Subject: Helitowcart- Dessins modifiés

Objet: Modification de dessin et création d'un nouveau dessin pour le BEARPAW

314-0011-00-A Installation Instructions - R44

BearPaw Model BP44

2 BOSCONS ANA-15A (forg.1.75") 2. FICCER BLOCKS UHMW.

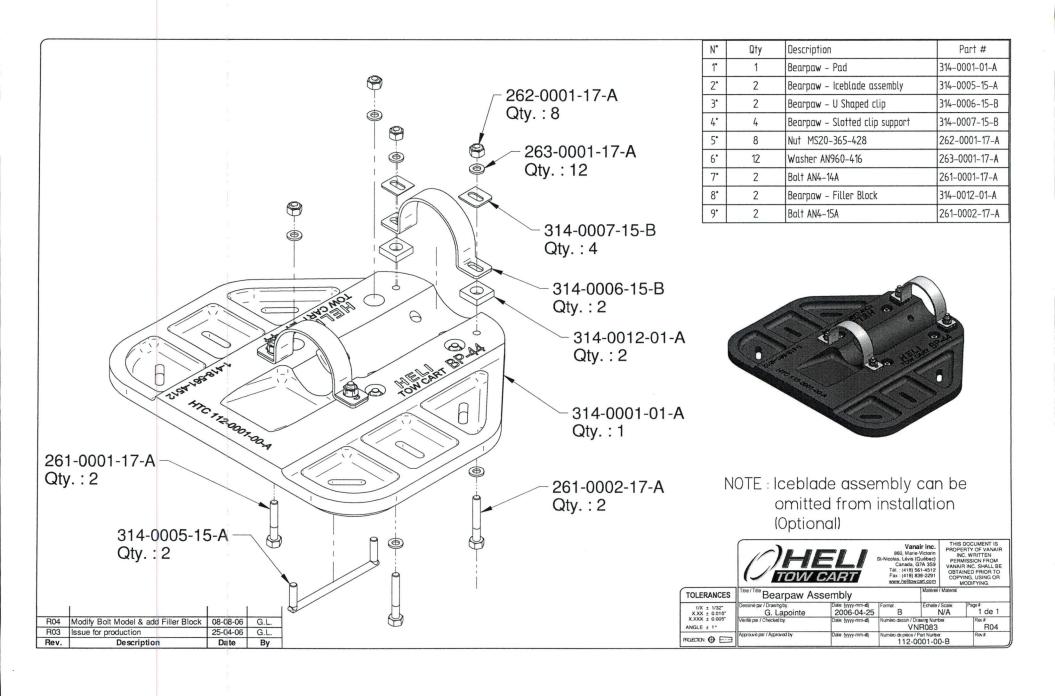
RAISON: TUBING TROP FORT À
L'AVENT. CLIP ENTRE TROPJUITE.

ALLONGER BOLT + Ajouter FILER

BLOCKS PERTET D'AMÉLIONER

SANS ANDIR à CRÉER UN U'CLIP

PULS GROS.

1) Remplacement du boulon AN4-14A (longueur 1.5") pour le clip avant, par le boulon AN4-15A. (longueur 1.75").

2) Ajout d'un filler block en UHMW. Nouveau part no: 314-0012-01A. Qté 2. qui sera utilisé sous le clip avant seulement.

2) Dessin d'ensemble de l'assemblage, annoté.

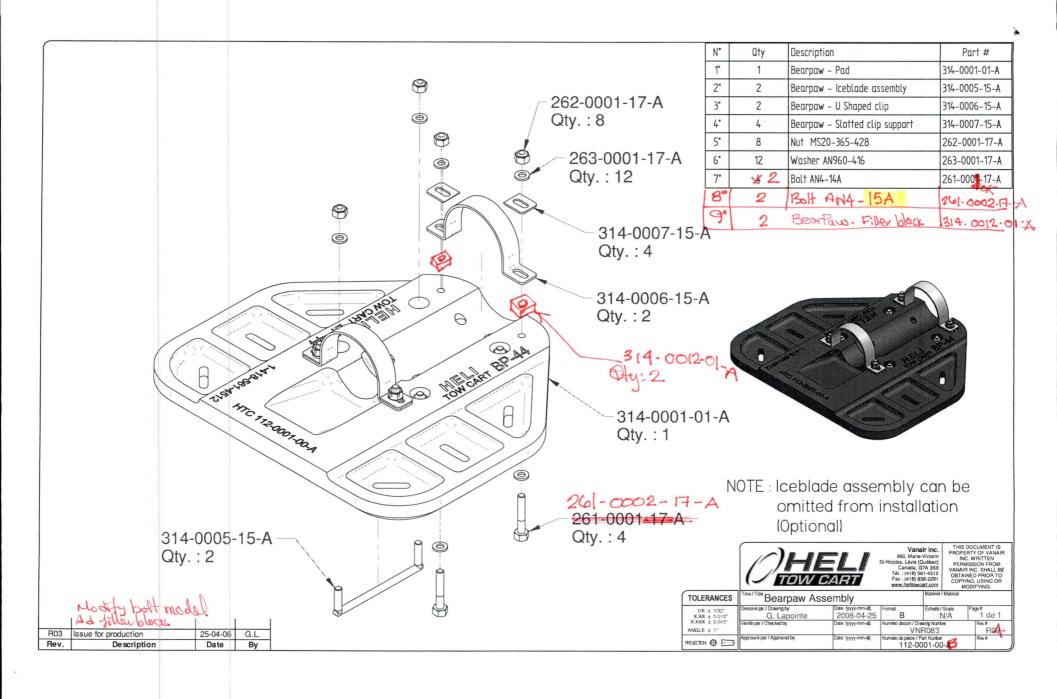
Suite au test en vol effectué vendredi dernier avec les BearPaw, on a besoin de faire des modifications. Trouve ci-joint la nature des modifs requises. En fait on a besoin d'ajouter un filler de UHMW de 0.25" d'épais sous le clip avant du bearpaw. Ce changement impose l'usage d'un boulon plus long. Svp effectuer modifications et me retourner les dessins.

0,8" J 0,25" 4HMW

Title: Filler block

Partilo: 314-0012-01-A

Annex A
BearPaw Assembly, Drawing no. VNR083.
P/N 112-0001-00-A

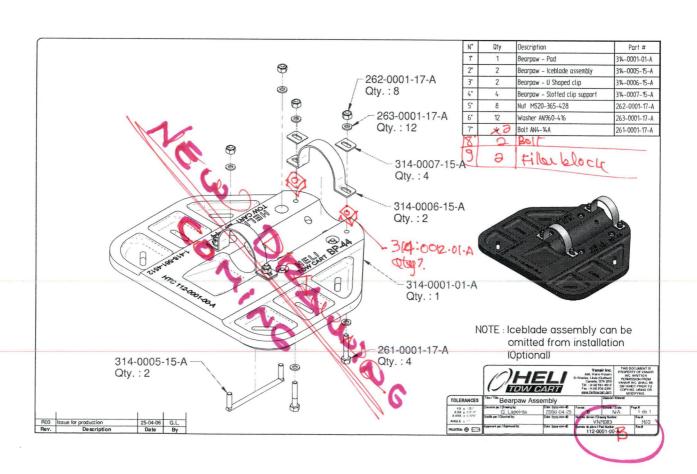
1) La modification du no dessin de AMEC: VNR 083 rev 04, la vision d'ensemble de l'assemblage, (notre no pièce/dessin: 112-0001-00-B)

Donc on a dorénavant Qté 2 x AN4-14A (part no 261-0001-17-A), et Qté 2 x AN4-15A (part no: 261-0002-17-A).
